13 March 2026

ADDENDUM NO. 2

RE: Leon, KS
Water System Improvements – Phase #2
WCI File: 23-600-636-00

SHEET NO:
C-103

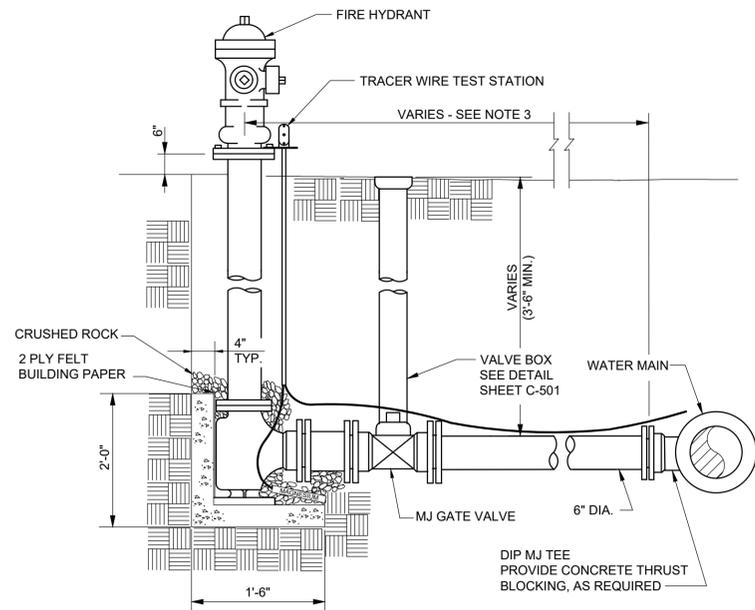
1. Sheet C-103
REMOVE existing sheet C-103 and REPLACE with attached sheet C-103 which REMOVES an abandonment note on the connection South of the intersection of Olive St & High St in Viewport A1.
2. Sheet No. C-502
REMOVE existing sheet C-502 and REPLACE with attached sheet C-502 which MODIFIES Note #3 in detail A4.
3. Sheet No. C-501
CLARIFICATION for Detail F7 on Sheet C-501 that existing setter inlet size is typical ¾". Contractor responsible for necessary fittings to connect with new 1" water service lines.
